CITY OF WINTER PARK PLANNING AND ZONING BOARD

Staff Report May 7, 2019

SPR 19-05 REQUEST OF Z PROPERTIES FOR APPROVAL TO CONSTRUCT A NEW 4,528-SQUARE FOOT SINGLE-FAMILY HOME LOCATED AT 1204 N PARK AVENUE ON LAKE MAITLAND, ZONED R-1AAA.

SPR 19-04 REQUEST OF Z PROPERTIES FOR APPROVAL TO CONSTRUCT A NEW 5,314-SQUARE FOOT SINGLE-FAMILY HOME LOCATED AT 394 HENKEL CIRCLE ON LAKE VIRGINIA, ZONED R-1AAA.

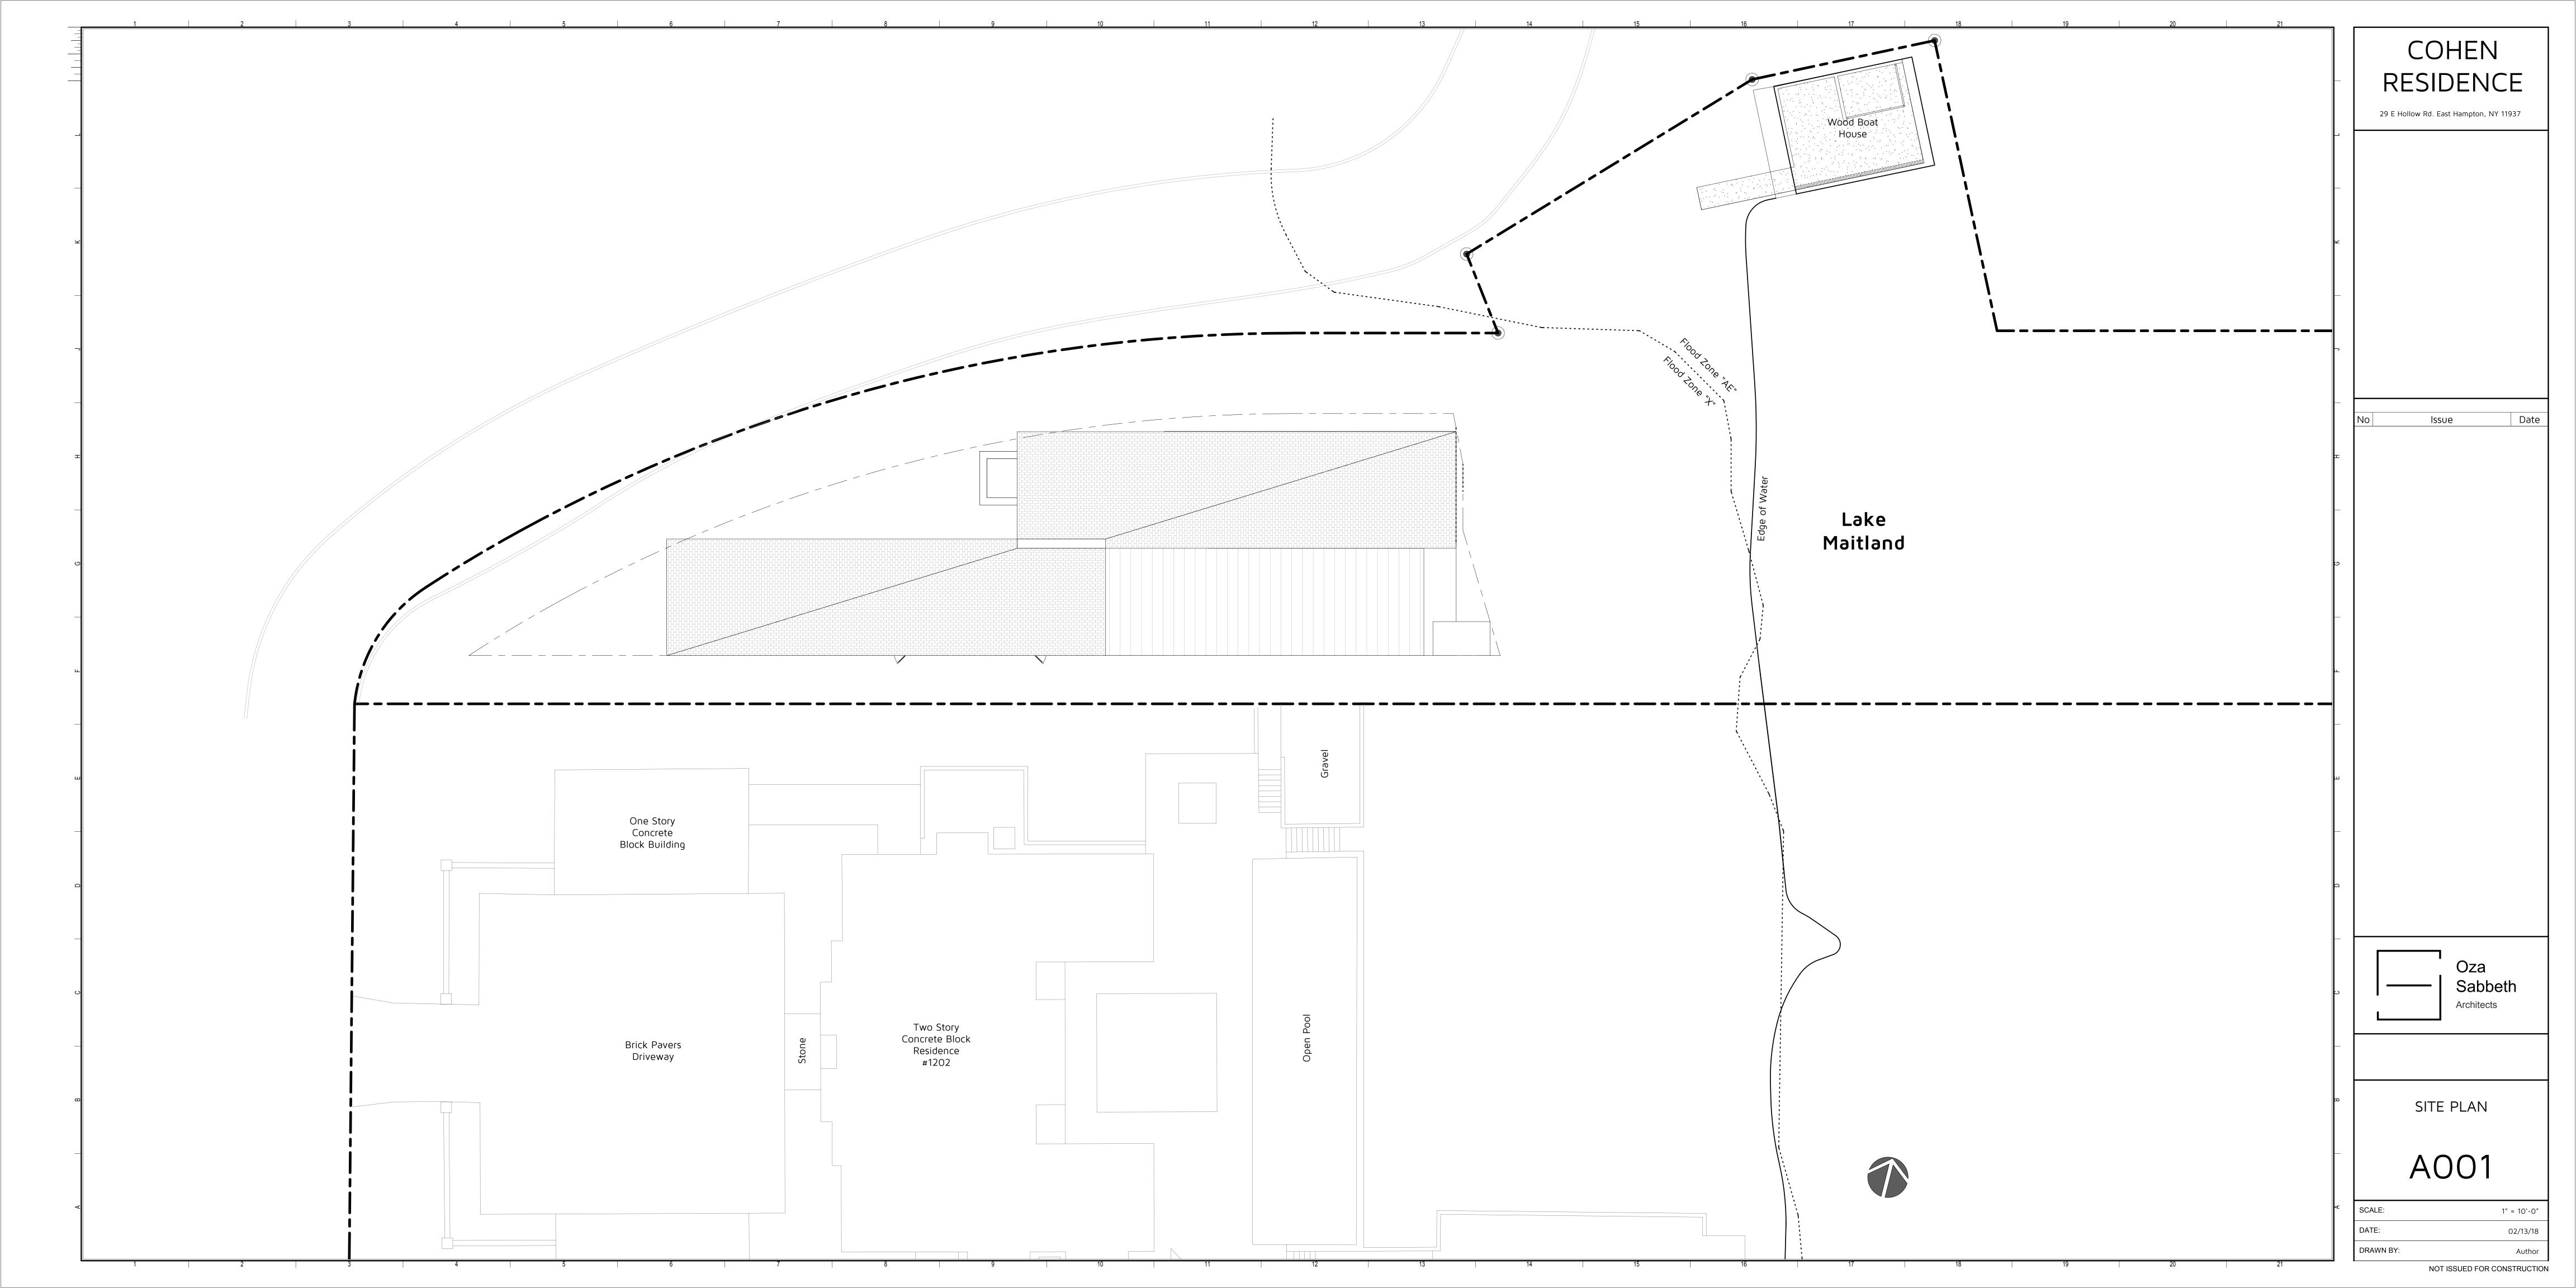
VIEW OF NEIGHBORS: The Code direction is to minimize the degradation of traditional views across properties by new houses, additions, second story additions, etc. alongside property lines toward the lake that may block traditional views. The attached site plan shows the orientation of this home versus the adjacent homes. Due to the constraints of the shape of this lot and the required setbacks, the rear of this house will be closer to the lake than the home to the south, but still behind the 50-foot lakefront setback and with the one-story height of this proposed home it will not impede the views of the lake of the neighboring properties.

STORM WATER RETENTION: The zoning code requires retention of storm water so that storm water flowing over a waterfront lawn area does not carry with it into the lake any fertilizers, herbicides, etc. Typically, this retention requirement is accomplished by the creation of a depressed swale area across the waterfront of about one foot in depth. The amount of impervious surface determines the need for the depth of the swale. The applicant is proposing a stormwater swale near the lakefront that is sized to meet the City's code requirements.

STAFF RECOMMENDATION IS FOR APPROVAL subject to the Building Department approval of the construction management plan.
